# UNITED STATES PATENT AND TRADEMARK OFFICE

APPLICATION NO.	FILING DATE	FIRST NAMED INVENTOR	ATTORNEY DOCKET NO.	CONFIRMATION NO.
10/618,650	07/15/2003	Hiroshi Kondoh	240266US2	5255
22850	7590	05/12/2005	EXAMINER	
OBLON, SPIVAK, MCCLELLAND, MAIER & NEUSTADT, P.C. 1940 DUKE STREET ALEXANDRIA, VA 22314			TRAN, LONG K	
			ART UNIT	PAPER NUMBER
			2818

**Office Action Summary**

**FIG. 2****FIG. 3**

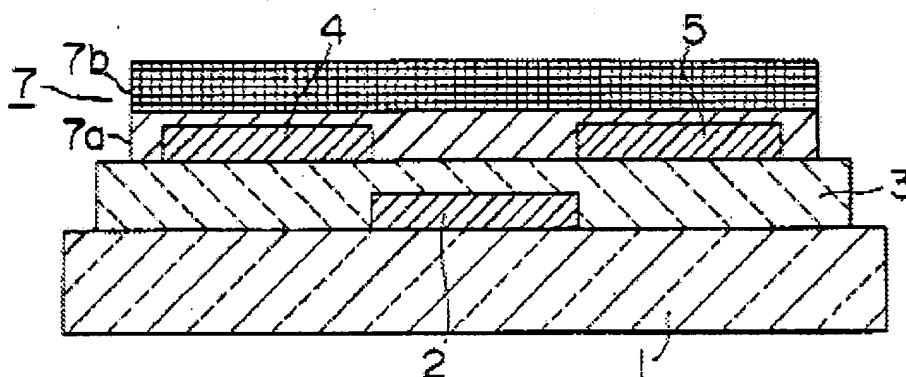
7. Regarding claim **1**, Tsumura discloses a semiconductor device, comprising: a gate electrode 2 (fig. 2);

an insulating layer 3 (fig. 2) on the gate electrode; a first electrode 4 (fig. 2) on the insulating layer; a second electrode 5 (fig. 2) on the insulating layer at an interval with the first electrode;

an organic semiconductor layer 7a (fig. 2; col. 6, lines 7 – 9) disposed in the interval between the first electrode and the second electrode and covering at least part of the first electrode and the second electrode; and

a first resistance layer 7b (fig. 2; col. 6, lines 7 – 9) formed on the organic semiconductor layer and having an electrical resistance lower than an electrical resistance of the organic semiconductor layer (col. 6, lines 18 – 21).

Regarding claim **2**, figure 2 illustrates both a distance from the first electrode to the first resistance layer and a distance from the second electrode to the first resistance layer appear to be shorter than the interval between the first electrode and the second electrode. Kim does not explicitly shows the values of the distances between the electrodes to the first resistance layer and the interval between the electrodes.

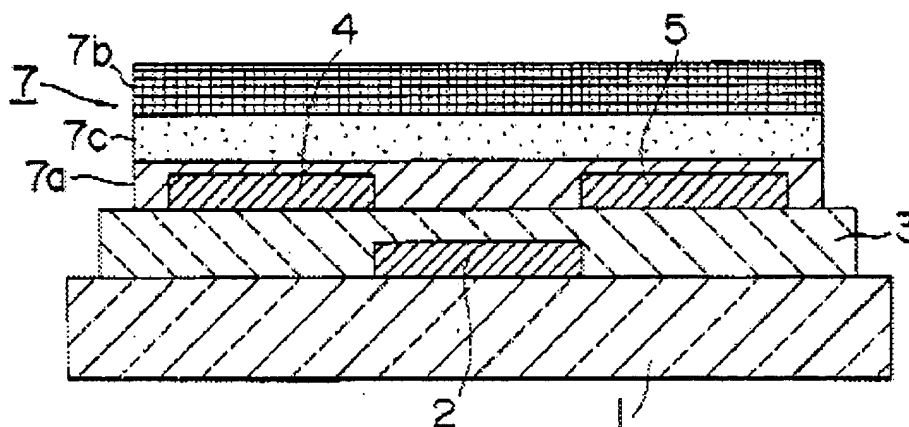
Regarding claim **4**, Kim discloses a second resistance layer 7c (fig. 3) formed at least at one of the position between the first resistance layer 7b (fig. 3) and the organic semiconductor layer 7a (fig. 3), wherein the second resistance layer has an electrical resistance so that carriers in the organic semiconductor layer are allowed to tunnel through the second resistance layer when a voltage of a predetermined value or more than the predetermined value is applied across the second resistance layer (col. 7, lines 24 – 35).

Regarding claim **6**, Tsumura discloses the resistance layer is formed to be a plate shape (figs. 2 & 3).
